To: Planning Commission

From: Community Development Department

RE: Application No. V-1447, by Derby Builders, on behalf of Jason House, a request for a rear setback variance of 15' where a 30' rear setback is required from the north property line for a primary structure addition.

Location of Property: 2430 Briarwood Place NE

Proposed Development:

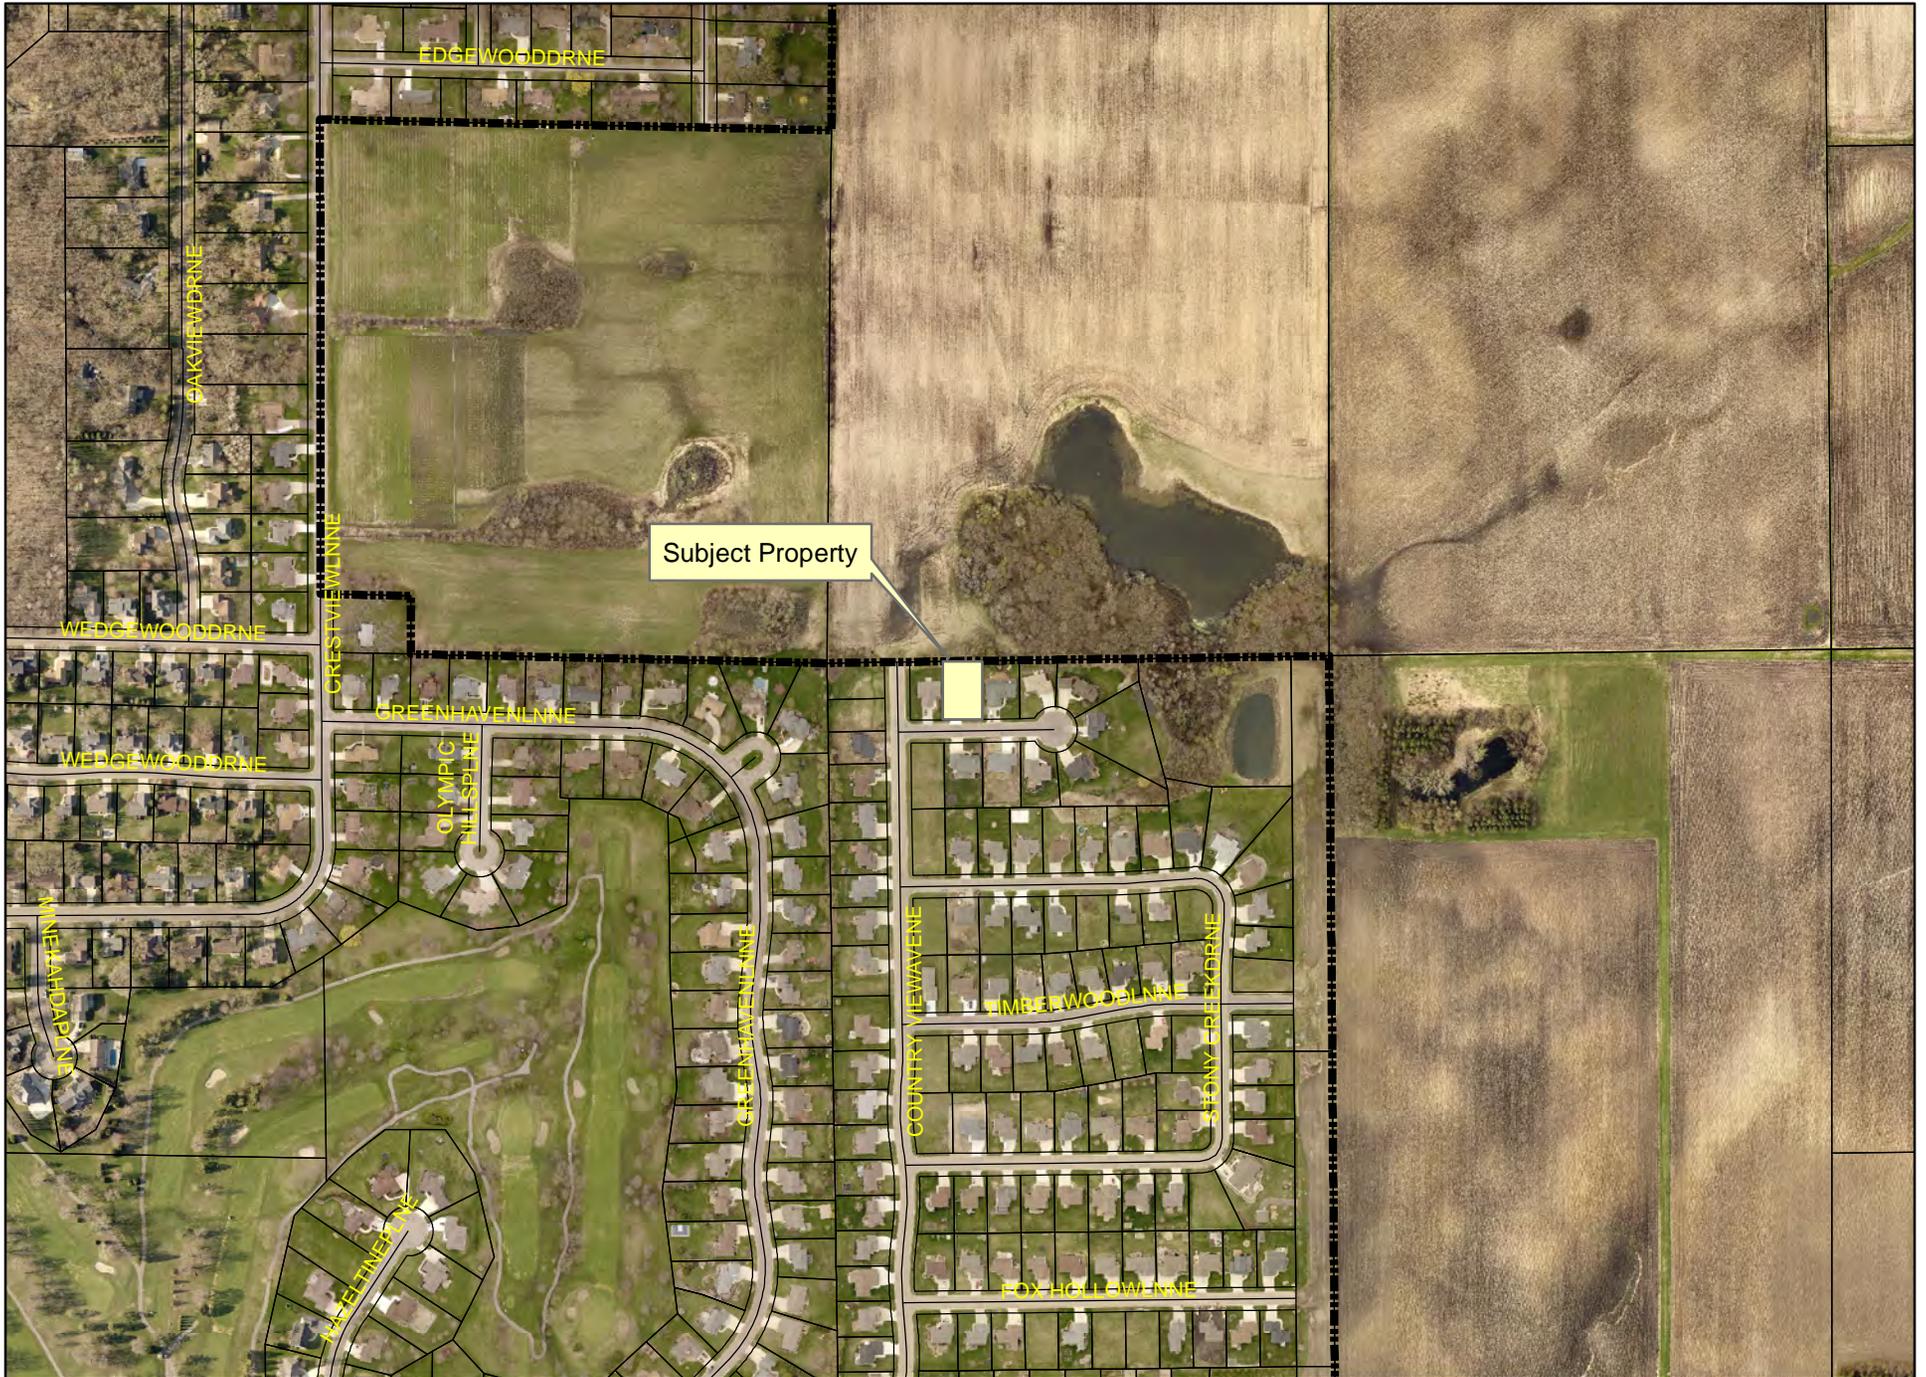
- ◆ The applicant is proposing to construct an addition on the rear of the house that will contain a 20' x 40' pool as well as the deck surrounding the pool.

- ◆ The proposed addition is 33' wide. The 15' of depth and 33' in width is the area that encroaches into the required setback.
- ◆ The addition will continue the existing line of the garage at a 10' setback to the west property line.

- ◆ The proposed addition does not encroach into any easements.
- ◆ The proposed addition will be a single story and contain a gable roof that has a height of 21' at the peak.

- ◆ The property to the north of this lot is not within the corporate limits. This area also contains two wetland complexes that show up on the National Wetland Inventory.

- ◆ This addition is near the smaller complex.
- ◆ Assuming Countryview Lane is extended to the north at some point in time, it is feasible there would be a lot fronting on Countryview in the future and would have a perpendicular lot to this one.

- ◆ Depending on the lot depth it may come near this addition but that is unclear at this time.
- ◆ As of the time of this report staff has heard from one neighbor that was inquiring on the request. The neighbor did not share an opinion on the request but asked numerous questions to address their concerns.

Based on the information provided Staff sees this request both ways. Staff is not making a recommendation on this request. If the request were to be approved Staff would recommend the following provisions:

- 1) There shall be no additional encroachments on the north side of the building.
- 2) All building codes shall be met.
- 3) No additional accessory structures shall be permitted on this parcel.
